UNITED STATES PATENT AND TRADEMARK OFFICE

Office Action Summary

10/511,824

DETAILED ACTION

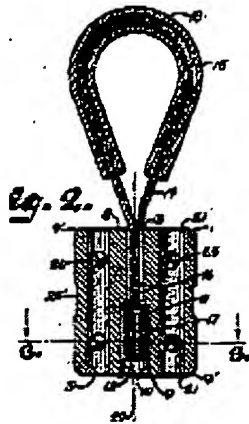
Regarding claim 1, Ensley teaches of a cable gripping device that comprises of an elongated housing (7) for receiving a cable axially with the housing being configured to permit an end of the cable to leave and be received back by the housing, forming a loop. Also, the device includes a means for securing part of the cable via a crimping method when the cable is received back by the housing. (See below).

Regarding claim 2, Ensley teaches of a tubular housing (7) wherein the cable passes along a central bore (10) of the housing. Regarding claim 3, Ensley teaches an aperture (11) that opens to one side of the housing with the cable leaving said aperture. Regarding claim 4, Ensley teaches of a recess (13) on a side of the housing opposite the aperture opening, wherein the cable is received in said recess. Regarding claim 6/3 and 6/4, Ensley teaches of a slanted aperture that guides the cable out of the aperture.

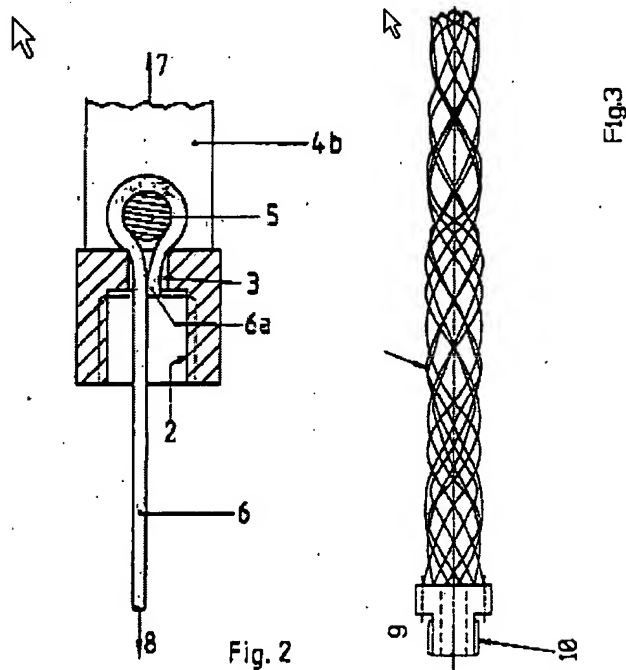
Bohle et al. teaches of a device for gripping and drawing a cable, comprising of an elongated tubular housing for receiving a cable (6) axially and where the cable

leaves at an aperture below the device head (5) at one end of the housing and is received back on another side of the same aperture, forming a cable loop at the same end of the housing. Bohle et al. further teaches of a backup lock (9) that has an external thread (10) that can be threaded into an internal winding (2) within the housing in order to further secure. Additionally, Bohle et al. teaches that the cable passes through the housing along a central bore (3), entering at a recess on the side of the housing opposite the aperture opening and exiting at the aperture. Finally, Bohle teaches that the aperture is slanted at 90° with the top of the aperture, thus guiding the cable out through the aperture. However, Bohle et. al. fails to teach of an initial first locking device with a biasing member that temporarily holds the cable loop against the head. (See Fig. 2 and 3 below).
